## SECOND/THIRD READING SUMMARY SHEET

**ZONING CASE NUMBER:** C14-2010-0087 (The Domain Rezoning-Simon)

## **ZONING CHANGE REVIEW SHEET**

**CASE:** C14-2010-0087 (The Domain Rezoning-Simon) **P.C. DATE:** August 10, 2010  
August 24, 2010

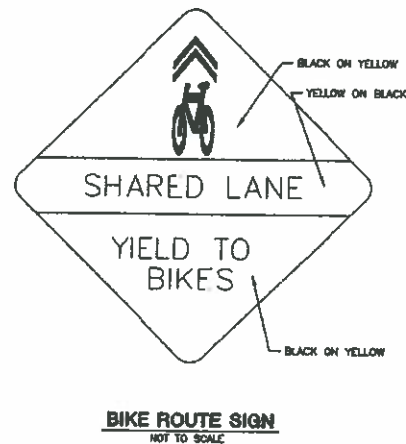
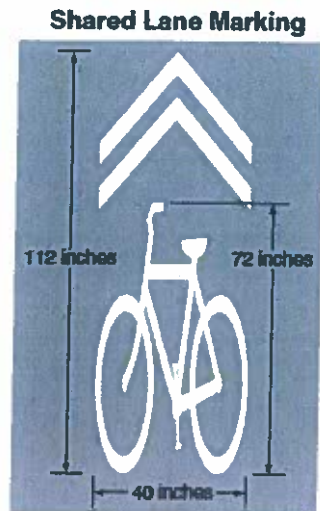
Additionally, the Bicycle Program recommends the installation of shared lane markings (sharrows) as depicted below along the following roadways:

The shared use markings (sharrows) shall be installed in compliance with the following standards:

- The shared land markings shall be placed with the tip of the chevron in the middle of the lane as measured from face of curb.
- A sharrow facility sign as shown below at a size no smaller than those signs currently installed on Kramer Ln. shall be placed at least 2 per block (one on each side of the street)
- Angled and head in parking prohibited on either side of roads with required sharrows.

## C14-2010-0087 (Simon)

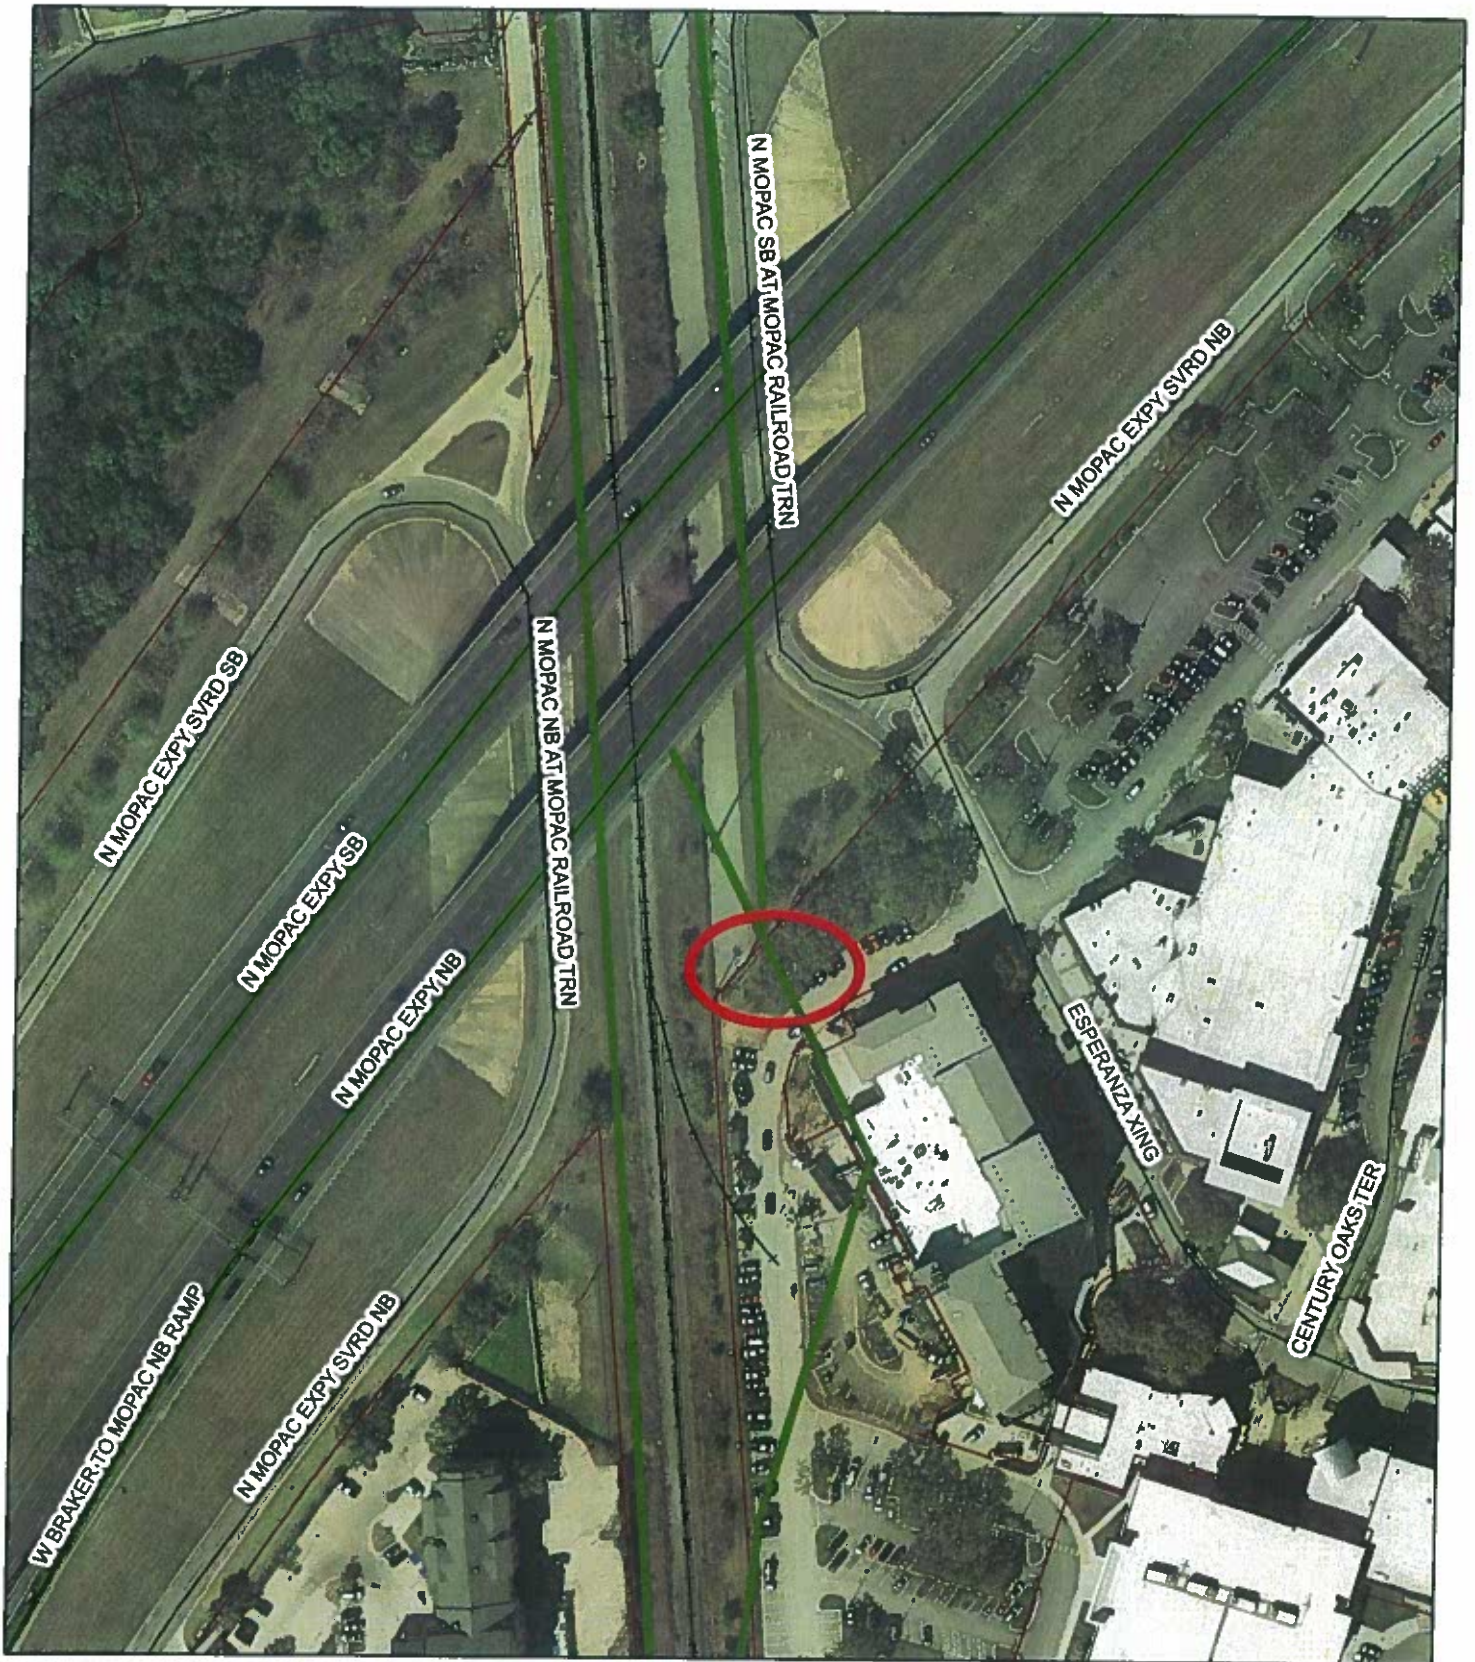
The City of Austin Bicycle Program recommends the applicant provide bicycle access and internal continuity for portion of Bicycle Route Segment #905.04 – Kramer LN from MOPAC EXPY N to Domain DR by providing and formalizing the pedestrian/bicycle entrance as identified on the attached bicycle network map including construction of a connecting minimum 12 foot paved path to the street with associated curb cut.

The formalized pedestrian/bicycle entrance, connecting path to the street, and shared lane markings (sharrows) shall be installed within one year of this agreement.
